Re: Alberta Heights
Lots 62 & 63
T.M. 9 B. 20 P. 115

### **CONFIRMATION OF PRE-FILE (2024-0014-P)**

DATE OF MEETING: 2/21/2024
	P&Z STAFF: Sara Anzelmo, Kelly Krinetz
APPLICANT/REPRESENTATIVE: <u>Valerie Johnson/Mike W</u>	erner - Anarex EMAIL: <u>mike@anarex.com. matt@anarex.com</u>
SITE LOCATION: 7616 WB&A Blvd	LOT SIZE: 7,020 sf ZONING: R1
ca designation: <u>N/A</u> BMA: <u>N/A</u> or Buffer:	N/A APPLICATION TYPE: Zoning Setback Variance

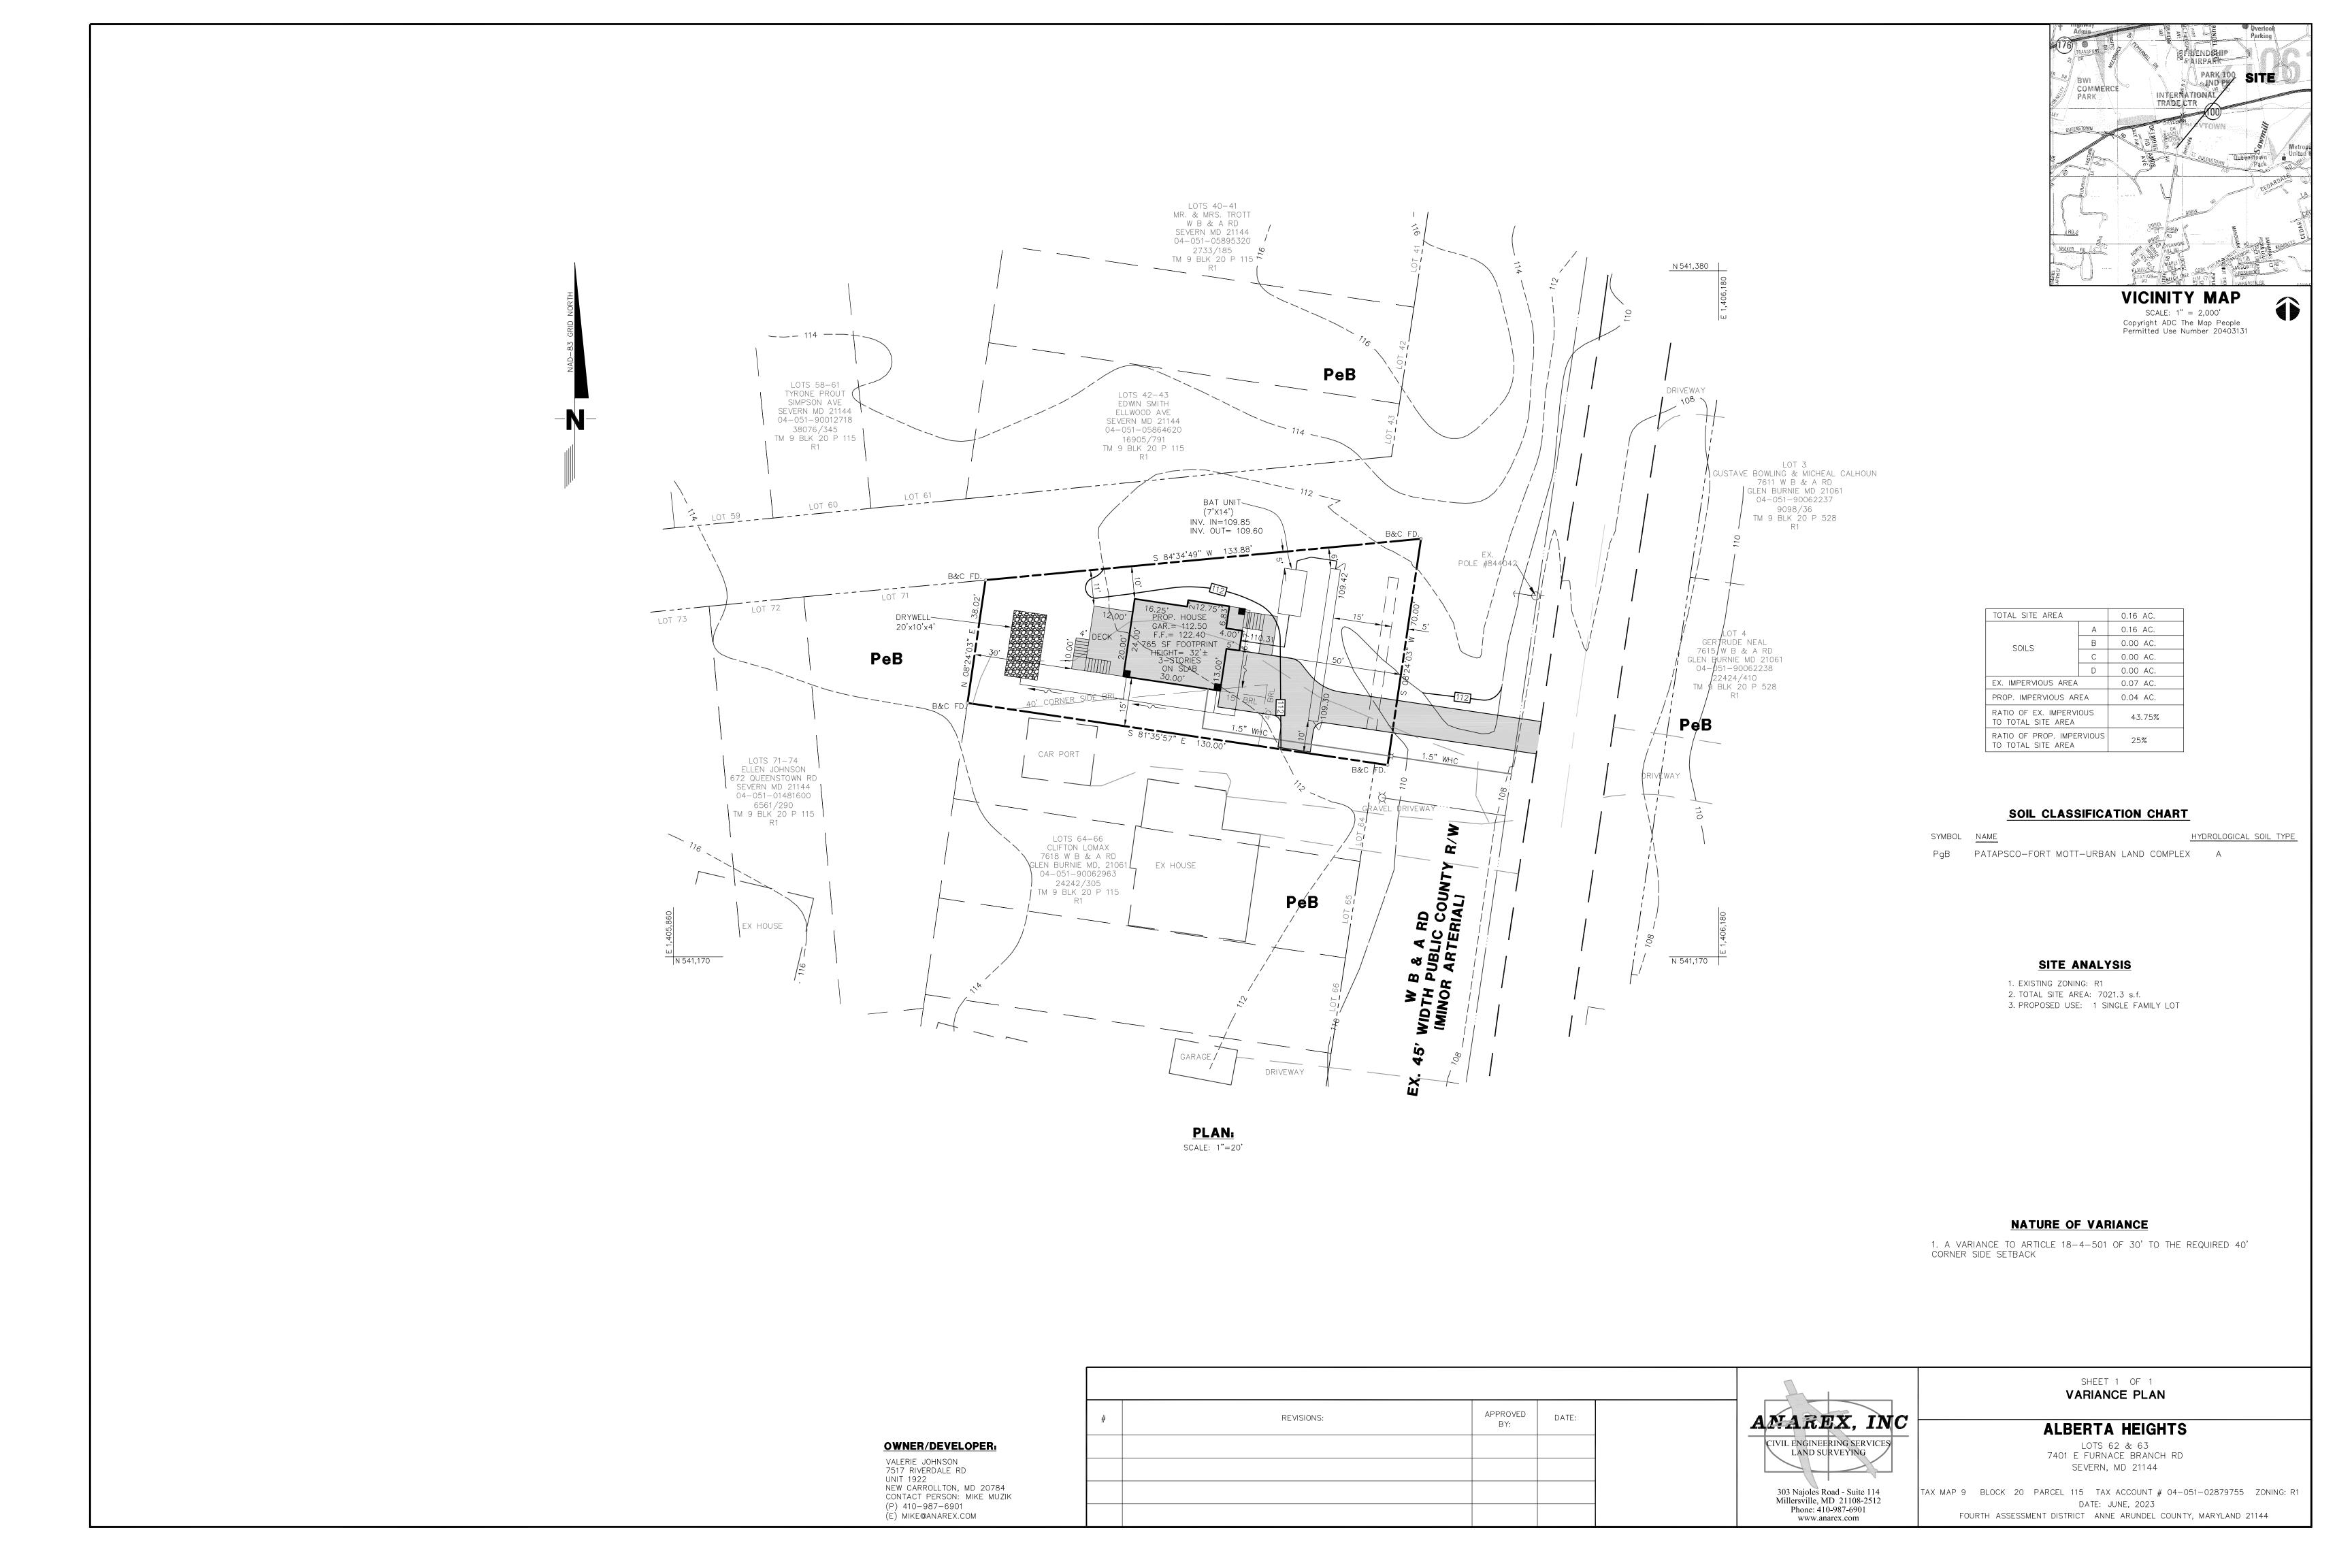
The **Zoning Administration Section** notes that all variance site plans require the proposed structures to be labeled with the height AND number of stories and should show whether or not a basement is proposed. The applicant is advised that, in order for a zoning setback variance to be approved, the applicant must demonstrate and the Hearing Officer must find that the proposal complies with the variance standards provided under Section 18-16-305 of the Code, including that the request is the minimum necessary to afford relief. The letter of explanation should describe why the specific location was selected and how the variance request represents the minimum necessary.

1. Based on the plan provided, it appears that the property will be served by public water and private septic. 2. Per the proposed design, ESD to the MEP is being addressed through the proposed dry well.

3. Soll borings are not provided to determine the suitability or siting of the practice. The suitability, and siting of proposed SWM practices should be reviewed. Soil boring information including verification of the suitability of in-situ soils for infiltration shall be submitted. A Geotech investigation should be performed.

4. The location of the property is flat grades, please ensure that no existing nutsance flooding issues will be exacerbated by the proposed development and that no surrounding properties are affected.

5. Infiltration devices, including individual lot devices, shall be located a minimum of 10 feet horizontally from any public sanitary sewer or house connection.

7. Based on the site conditions, the information shall be provided to verify how the following are reviewed and applied in the BMP selection for the site and ensure that the BMPs proposed meet requirements from MDE Stormwater Manual chapters 4 and 5. Watershed Factors;

b. Terrain Factors; c. Stormwater Treatment Suitability; d. Physical Feasibility Factors; e. Community and Environmental Factors; and f. Locational and Permitting Factors. 8. As a part of the Environmental site Design, it shall be verified that site design includes protecting natural resources. At this time, this office does not have this information.
In Possession Time (hrs) ne Tracking Start Date Est. Completion Date In Possession Time (Brs) splay E-mail Address in ACA Splay Comment in ACA Comment Display in ACA All ACA Users Record Creator Licensed Professional €. Contact Owner timated Hours Action Workflow Calendar Updated k Specific Information Reviewer Phone Number wiew Notes Reviewer Name
